UNITED STATES PATENT AND TRADEMARK OFFICE

APPLICATION NO.	FILING DATE	FIRST NAMED INVENTOR	ATTORNEY DOCKET NO.	CONFIRMATION NO.
10/530,549	01/30/2006	Kazuhiko Fukutani	03500.102994.	7631
5514	7590	08/08/2006	EXAMINER	
FITZPATRICK CELLA HARPER & SCINTO 30 ROCKEFELLER PLAZA NEW YORK, NY 10112			SINES, BRIAN J	
			ART UNIT	PAPER NUMBER
			1743

Office Action Summary

DETAILED ACTION

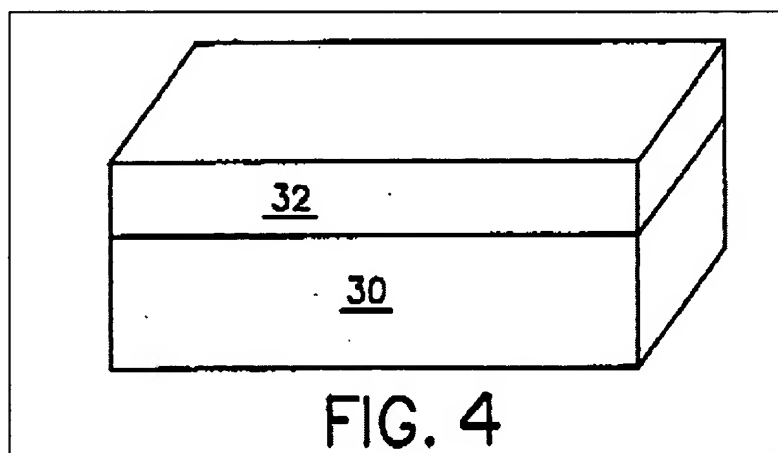
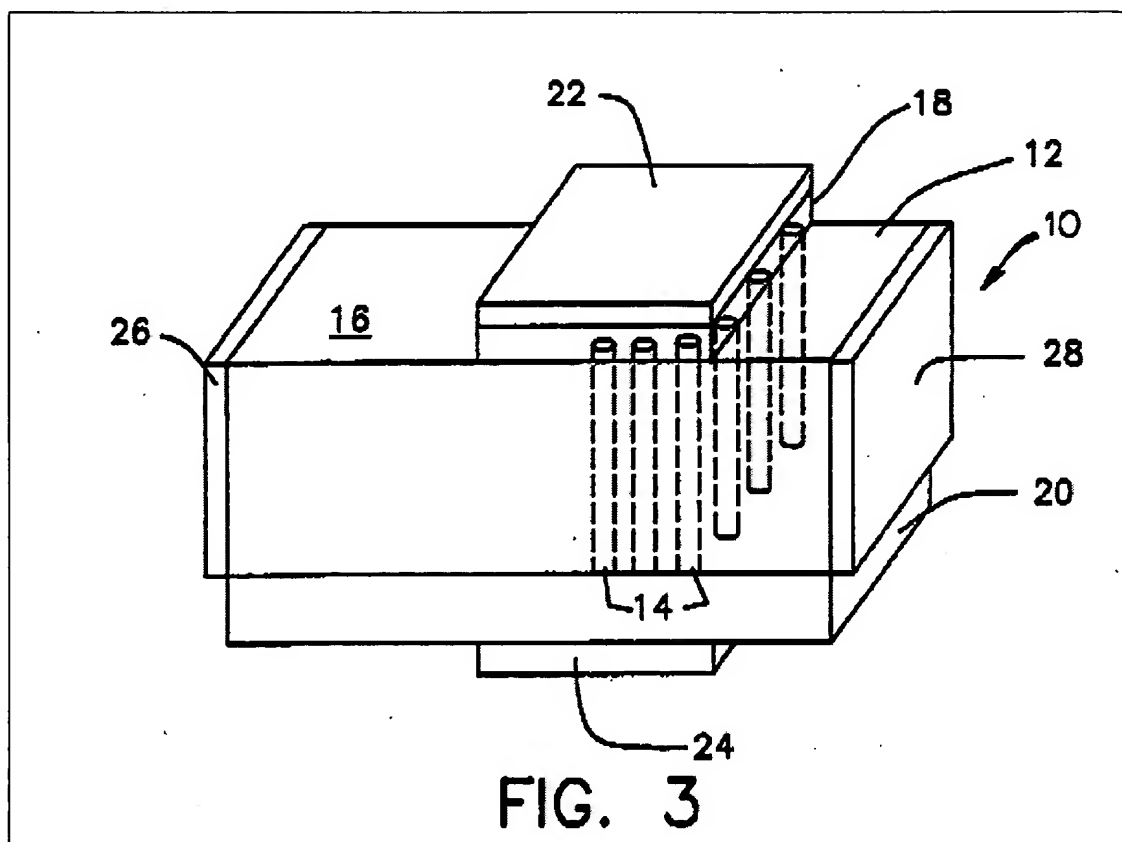
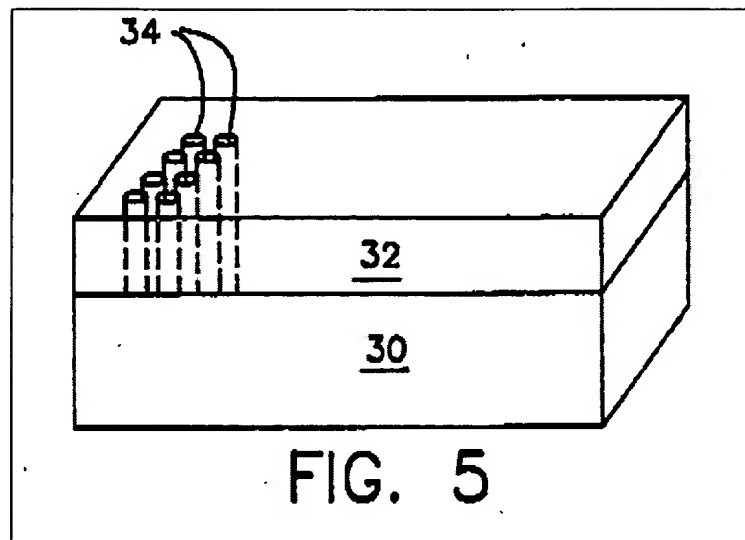
Claims 1 – 5, 7 and 10 are rejected under 35 U.S.C. 102(b) as being anticipated by Kurtz et al. (U.S. Pat. No. 5,359,214 A) (hereinafter "Kurtz").

Regarding claims 1 – 5 and 10, Kurtz teaches a field effect transistor device (10) comprising: a substrate (e.g., 12) comprising a source and drain region (26 and 28, respectively); an insulating layer (p-type gate 20) arranged on the substrate; and a porous body comprising pillar-shaped or cylindrical holes (14) arranged on the insulating layer, wherein the porous body includes a semiconductor material (see, e.g., col. 3, line 6 – col. 4, line 63; figures 3 – 5). Kurtz anticipates the use of silicon materials (see, e.g., col. 4, lines 33 – 50).

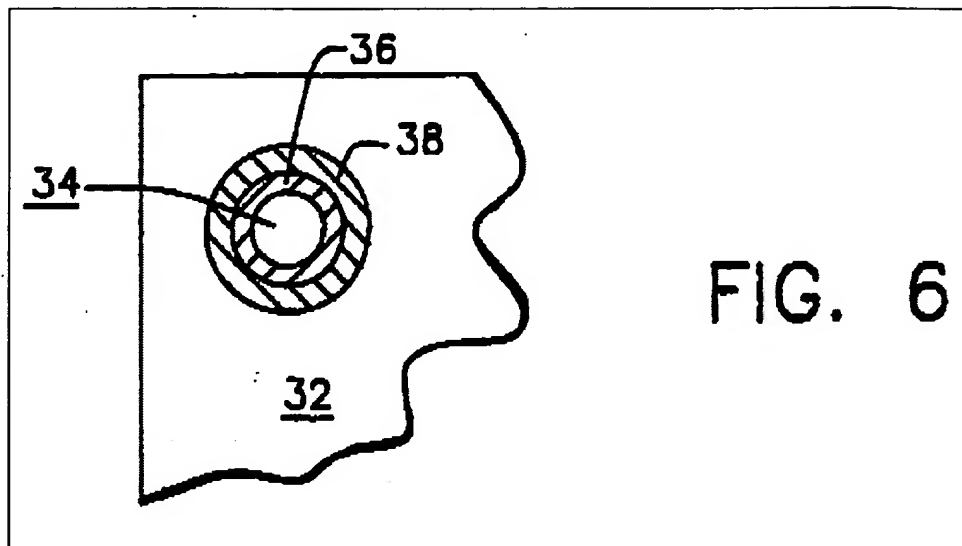
Regarding claims 7, Kurtz teaches the incorporation of an additional detection material (36 and 38) within a pore (34) (see, e.g., col. 4, lines 51 – 63; figure 6).
